STATE OF WASHINGTON
DEPARTMENT OF ECOLOGY

Re: Quarterly Notification of Class 1 Modifications to the Hanford Facility Resource Conservation and Recovery Act (RCRA) Permit, Dangerous Waste Portion (Quarter ending December 31, 2000 – Condition I.C.3)

Hanford Facility RCRA Permit Modification Notification Forms

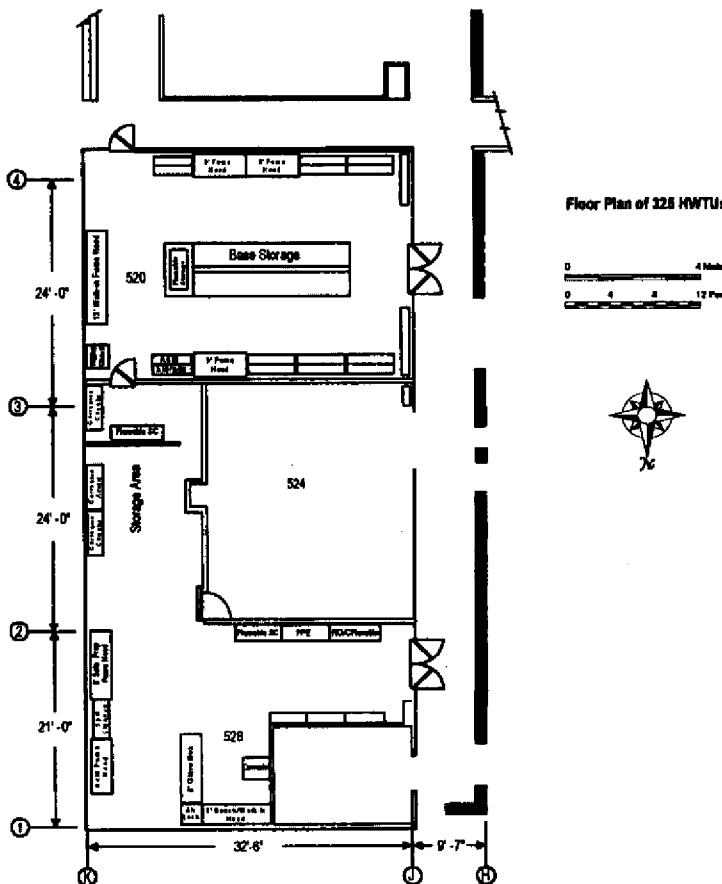
| Hanford Facility RCRA Permit Modification Notification Form | | | | |
|--|---|--|---|---------|
| Description of Modification: Remove Chapter 11.0 and replace with the attached Chapter 11.0. Appendix 3A, Figure 1-4: Updated Figure 1-4 to reflect current layout. | |  <p style="text-align: right; font-size: small;">Floor Plan of 325 HWTUs</p> <p style="text-align: right; font-size: x-small;">0 4 8 12 Feet</p> <p style="text-align: right; font-size: x-small;">SG07030285.2</p> | | |
